*Preliminary*  
**MONTGOMERY COUNTY HISTORIC PRESERVATION COMMISSION**  
**STAFF REPORT**

<b>Address:</b>	26 Oxford St., Chevy Chase	<b>Meeting Date:</b>	12/20/17
<b>Resource:</b>	Non-Contributing Resource Chevy Chase Village Historic District	<b>Report Date:</b>	12/13/17
<b>Applicant:</b>	Gerstenfeld/Wiltshire	<b>Public Notice:</b>	12/06/17
<b>Review:</b>	Prelim	<b>Tax Credit:</b>	N/A
<b>Case Number:</b>	N/A	<b>Staff:</b>	Dan Bruechert
<b>Proposal:</b>	Demolish out-of-district resource, construct addition, hardscape alterations

Figure 1: 26 Oxford St., marked with a star is next to 6320 Broad Branch, which sits outside of the Historic District.

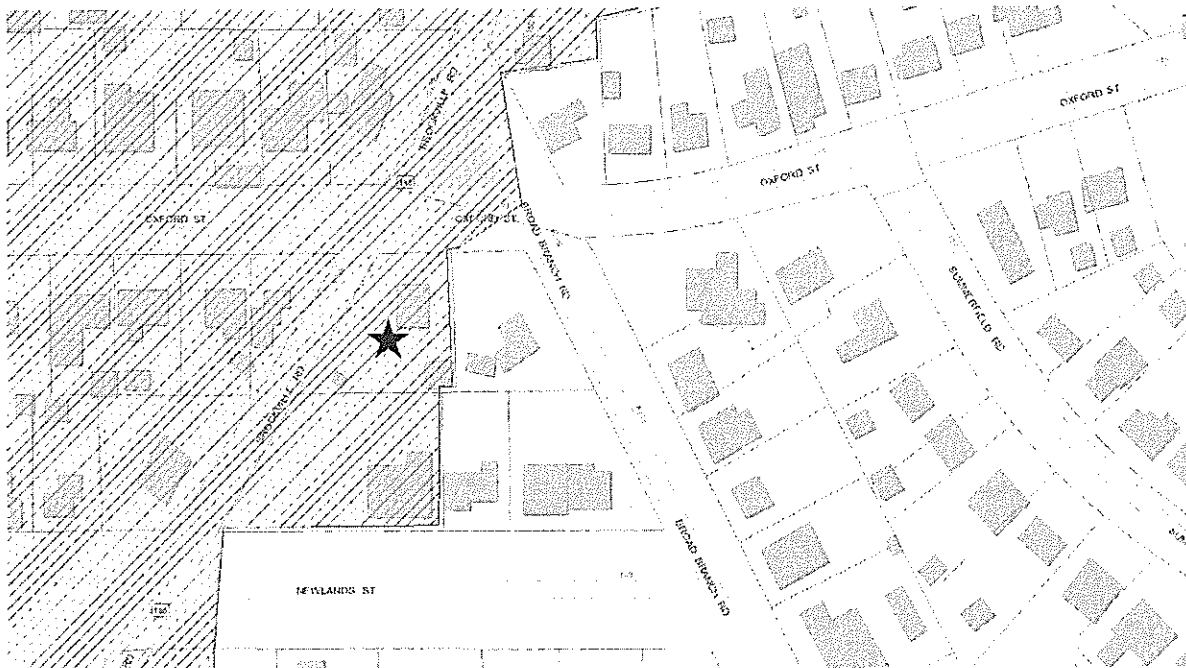
The house at 6320 Broad Branch Rd. lies outside of the historic district. Its orientation faces away from Oxford St. and it does not contribute to the historical context to evaluate 26 Oxford St. As this building is outside of the Historic District, Staff does not believe that the HPC has the authority to approve or deny the demolition of this building. However, the demolition of this building will have an impact on the siting of the non-contributing building at 26 Oxford St. The reason Staff has included this information in the prelim is help the HPC understand the context of the changes being proposed in the other areas of this prelim.

EXISTING ELEVATION TO 1/2 STORY ADDITION 11-27-17

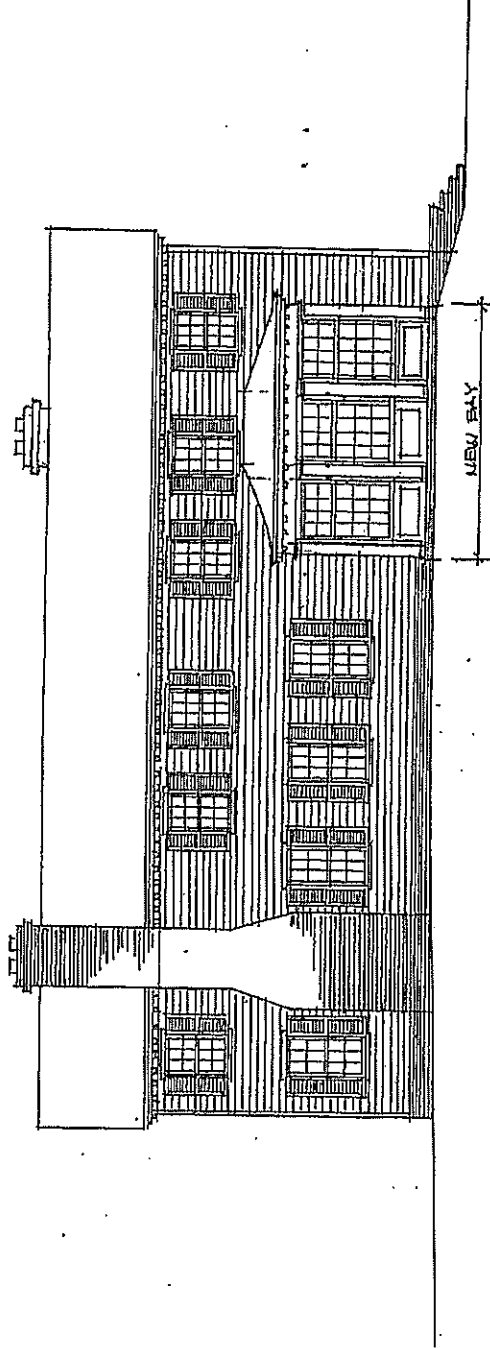
In the main massing of the house the applicant is proposing to remove the front door and replace it with a six-over-six sash window that will match the appearance and configuration of the other windows in the house. In place of the current side addition the application proposes to construct a new two-story addition that will effectively double the width of the existing house. A new door matching the decorative pediment of the existing door will be installed in this side addition. The details of the addition will match the main block of the house in siding, window configuration, cornice details, and shutters. To the left of the two-story addition is a one-story hyphen with a 1 ½ story side gable addition to the left. The 1 ½-story addition contains a two-bay side-loading garage and will match the details and appearance of the other addition. The 1 ½-story addition will be placed entirely on the lot currently occupied by 6320 Broad Branch Rd.

contributing house. The architectural details including roof shape, siding, windows, and shutters will all be consistent between the main house and the additions. The additions will have lower roofs, as the two-story addition's gable ridge will be lower than the front gable on the main house and the 1 ½-story garage will further step down. Staff recognizes that this is a large addition that would not likely be appropriate on many lots within the Chevy Chase Village Historic District. As this addition is occurring on the side of the house that faces away from the district and the additions are proposed on what will be a double lot, Staff feels that the size may not overwhelm the site and surrounding district.

WILSHIRE RESIDENCE - WEST ELEVATION 2 1/2" x 11" - JONES & BROS. ARCHT'LS. 11-21-17

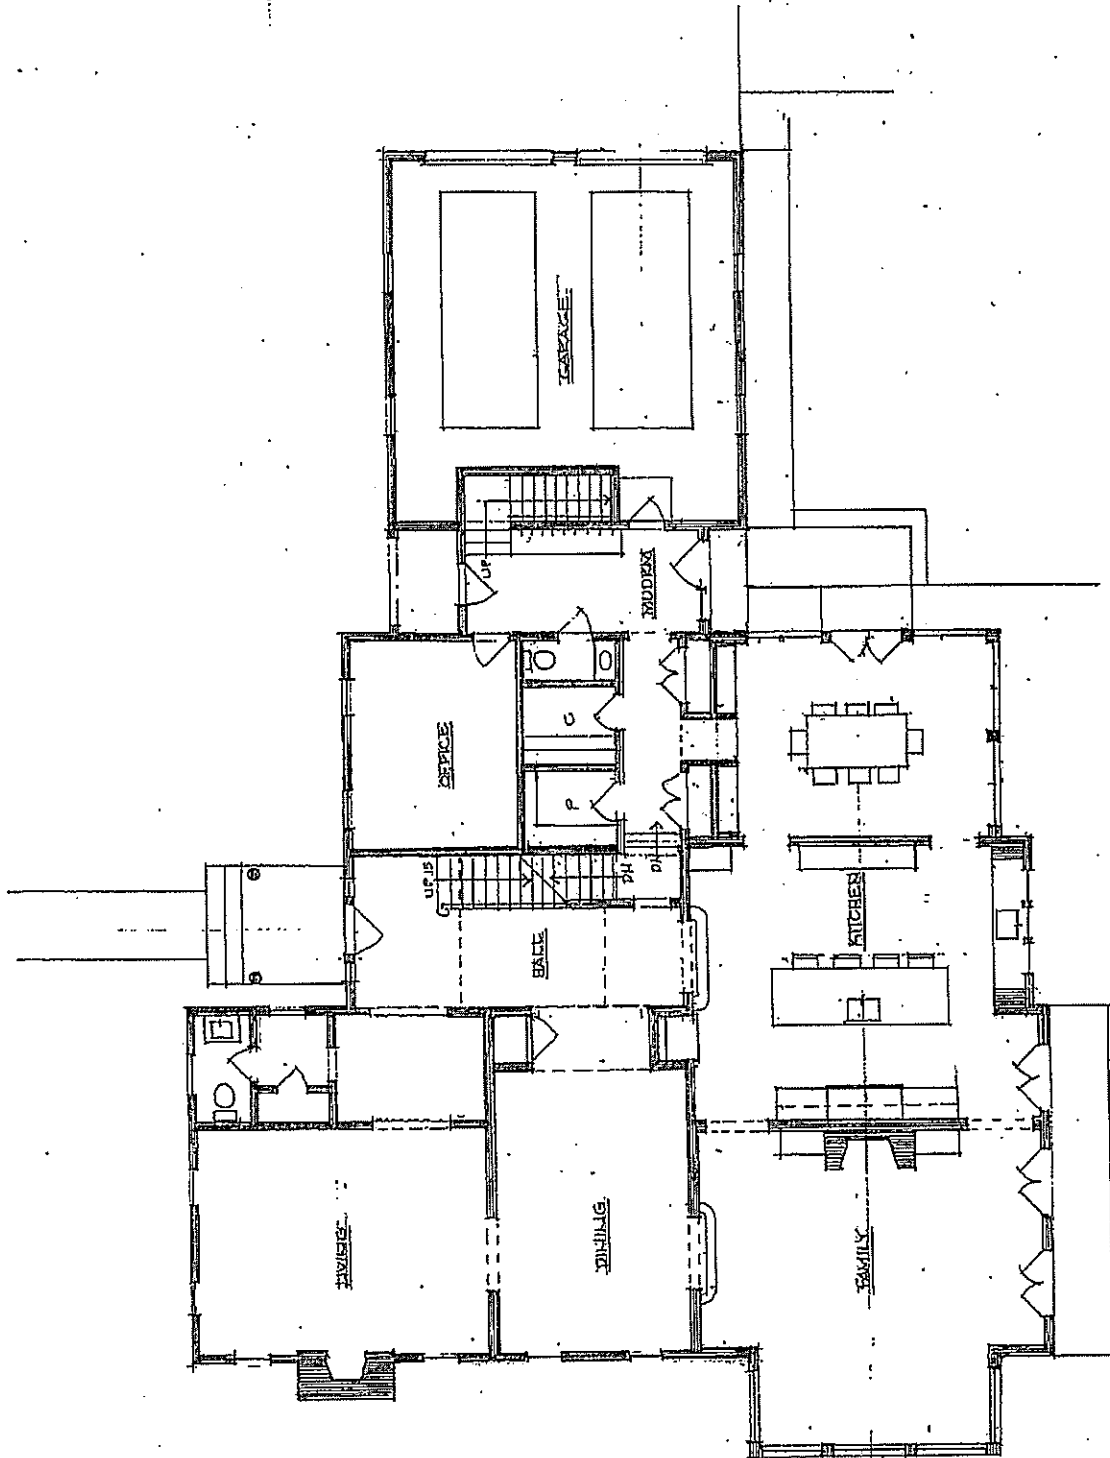
The applicant is also proposing to expand an existing bay on the west side of the house. The applicant did not provide existing drawings for this preliminary application, but it appears as though the new bay will be between 33-50% larger than the existing bay. This side of the house faces Brookville Rd. and the interior of the historic district. Staff feels that more information is needed for this element to be fully evaluated. Specifically, details on the proposed windows, roofing, and existing drawings should be presented with the HAWP application for a full evaluation. Staff believes, however, that an expansion of the existing bay can be accommodated to this secondary elevation and that it will not overwhelm the existing house or the surrounding streetscape.
